## G70-C GENERAL PERMIT ENGINEERING EVALUATION

APPLICATION NO.: **G70-C205**

Facility Name: **Terry Snyder Well Pad**

Description of Permitting Action: **Registration application for an oil and natural gas facility.**

Overhead Google Earth Image of Facility:

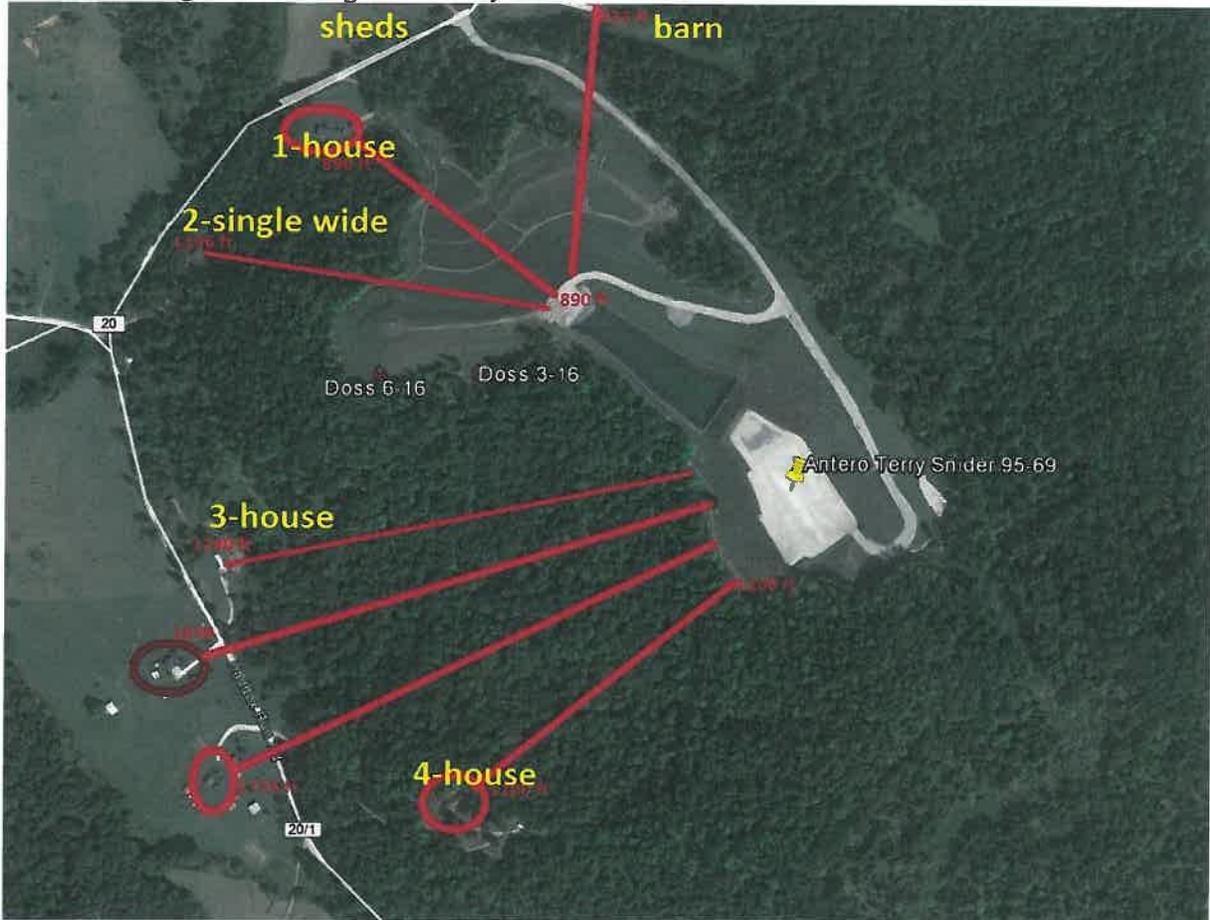
Results of Site Inspection: Re G70's 300 ft proximity minimum, there are **No Residences within 300 ft.**

Per attached, closest house is ~890 ft NNW from the edge of the site.

There are four (4) houses around the base of the hill below the pad ~1100 ft from the site, and others located nearby, across the road or greater distances.

Site work had been completed and the pad was being prepped for drilling operations.

No equipment was on site while I was there.

In my opinion this site is suitable for a General Permit.
